US ITER 1020100-TD0017-R00
2.6.P1A_B.US.01.0

ITER TCWS Conceptual Design Chit Resolution Report

February 2012

Fig. 1. IBED PHTS Double Isolation Valves.

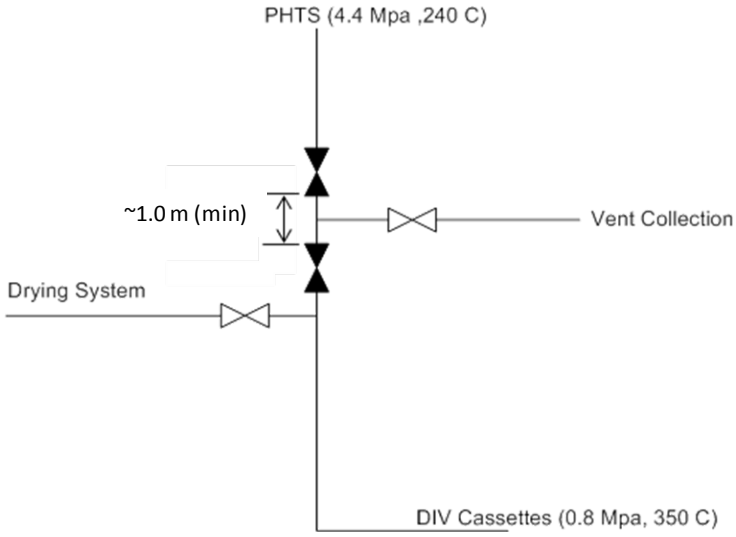
Item #	Issue Statement
1	Design strategy for isolating the baking and cooling circuits during divertor baking needs to be defined. Are suitable isolating valves available?

To ensure no cross leakage between high pressure water and hot gas during the DIV gas baking, double isolation valves are used in two locations within the IBED PHTS system as shown in the simplified sketch, Fig. 1, with valves positioned for DIV gas baking. Any leakage from the gas side or the water side is collected and sent to the Vent Collection System.

The isolation valves are separated by a minimum distance of approximately 1.0m to minimize temperature gradients and heat conduction from the high temperature side (350ºC nitrogen gas) to the low temperature side (240ºC water). For a DN500/Schedule 80 pipe insulated with 82mm thick mineral wool, a distance of 1.0m is sufficient for a smooth transition from 350ºC to 240ºC. It was estimated that the convective heat transfer in the pipe section between two valves is negligible (approximately 40W). For conservatism and simplicity, the estimate neglected the heat loss from the valve bonnet, stem and yoke, and assumed that the gas side isolation valve is immediately adjacent to the drying system tie-in point. If the valve is further away from the tie in point, it will be at a lower temperature than the 400ºC conservative upper bound of the gas temperature, and the resulting temperature gradient will be lower.

Fig. 2. PRT and associated Nozzles/Connections (Reference [5.1.7], [TBV-002]).

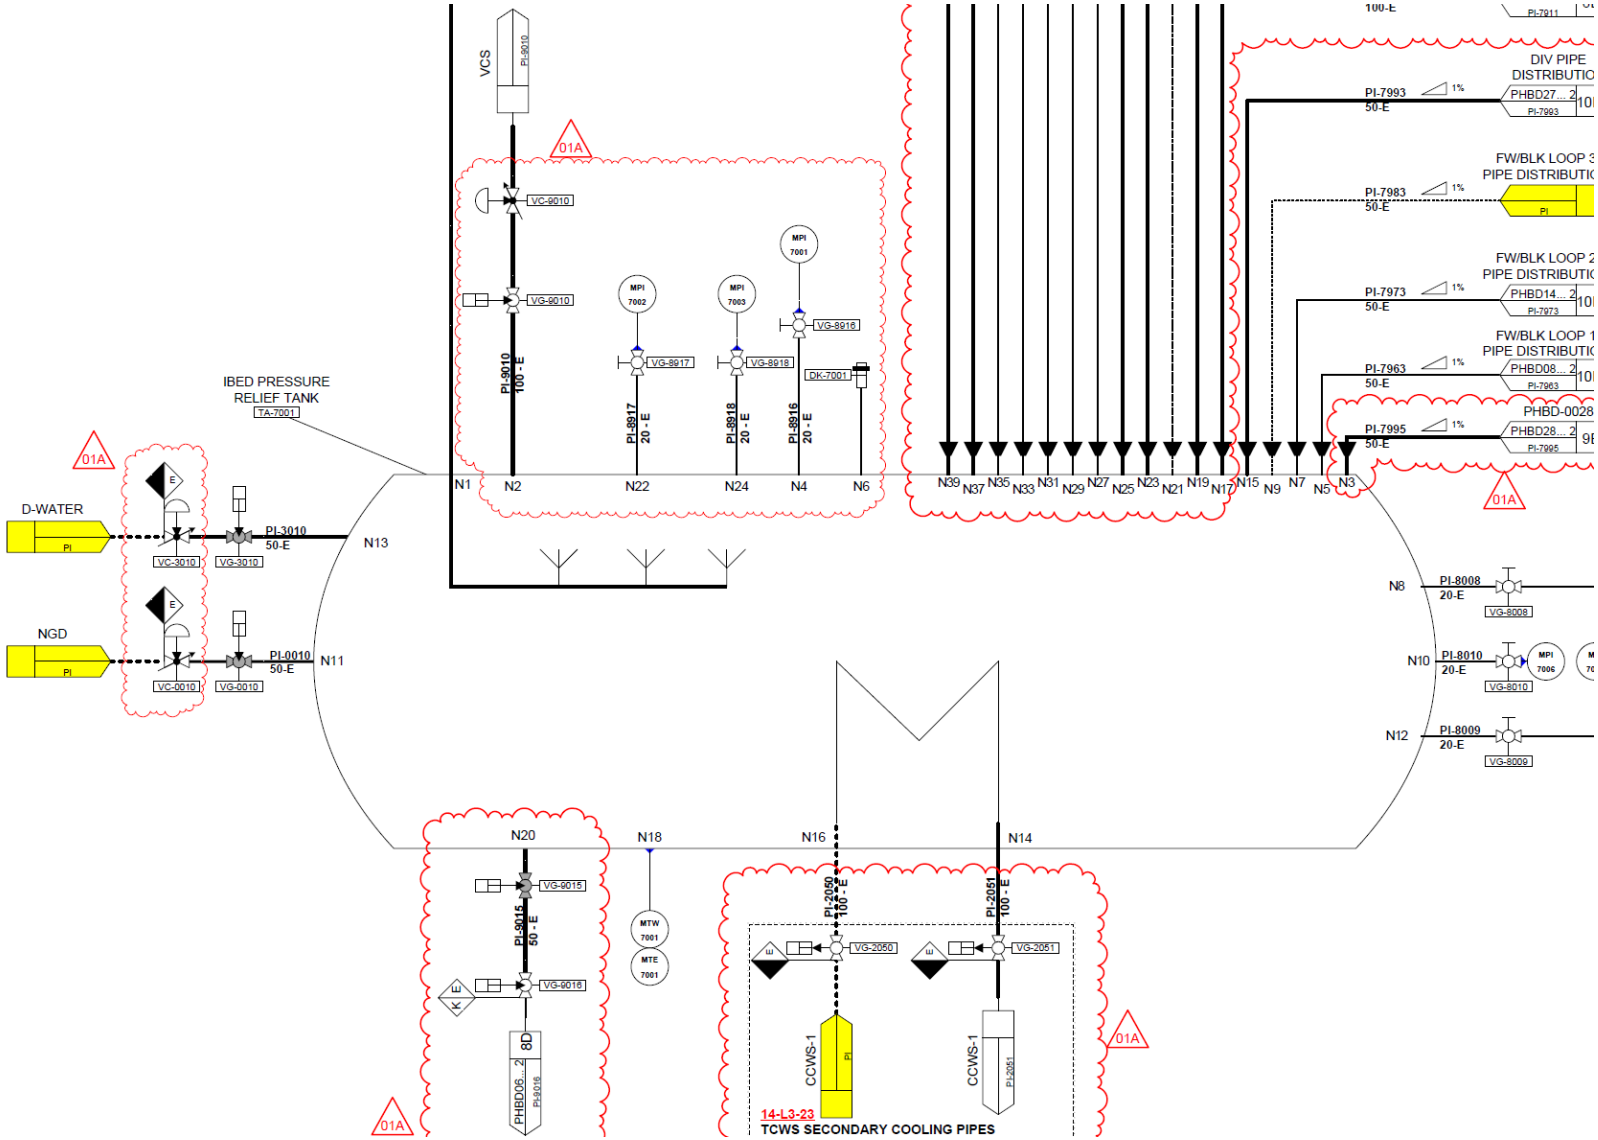
Item #	Issue Statement
2	Conceptual design of the Pressure Relief Vessel should accommodate overfilling including bursting disc and vent line. Adequate cooling via CVCS and appropriate vacuum relief for correct draining is required.

The pressurizer relief tank (PRT) is equipped with a rupture disc (DK-7001) which discharges to the TCWS vault for overpressure protection (See Fig. 2, [TBV-002]) and a vent line (N2) which discharges to the Waste Collection System and drain pipe (N20) that discharges to drain tanks.

The PRT is designed to accommodate a vacuum. This operating condition occurs when air is removed from the PRT by drawing a vacuum via the N-VDS vacuum pump prior to refilling the PRT with nitrogen. The draining is a slow, controlled process, and the tank pressure can be modulated with Nitrogen Gas Distribution. Therefore, a vacuum breaker is not required for draining the PRT.

A cooling coil inside the tank provides cooling of the liquid inside the PRT. The cooling water is provided by the CCWS.
